# USB Type-C ENGINEERING CHANGE NOTICE

**Title: Type-C to Standard-A cable figure update**

**Applied to: USB Type-C Specification Release 1.0, August 11, 2014**

### (a). Section 3.5.1, Figure 3-21, Page 58

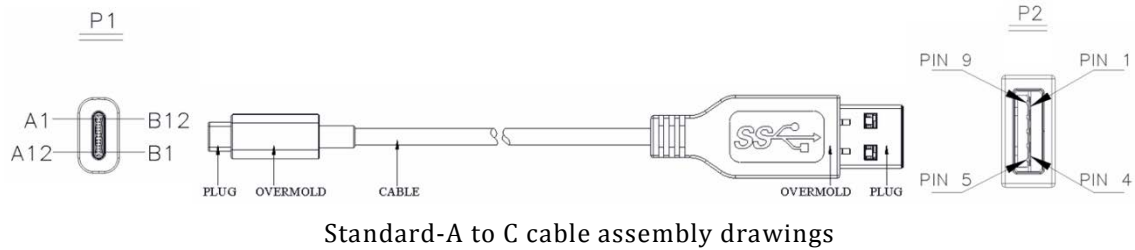
Figure 3-22 shows an incorrect pin labeling on the Standard-A connector. This ECN corrects the pin labeling on Figure 3-22 and updates Figure 3-21 to provide a common format for both Type-C to Standard-A cable figures.
--

From Figure:

To Figure:

Editor's note: Delete "Standard-A to C cable assembly drawings" from beneath figure.

### (b). Section 3.5.2, Figure 3-22, Page 59

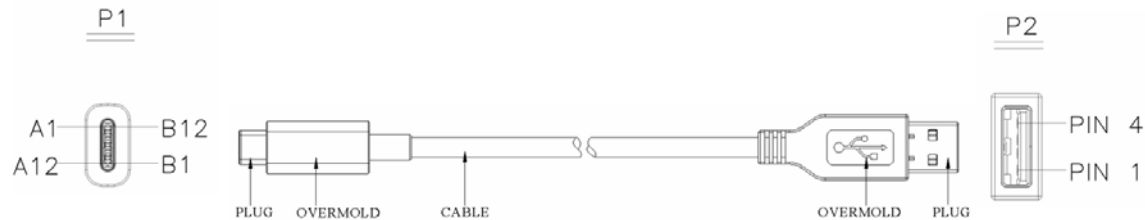
From Figure:

To Figure:
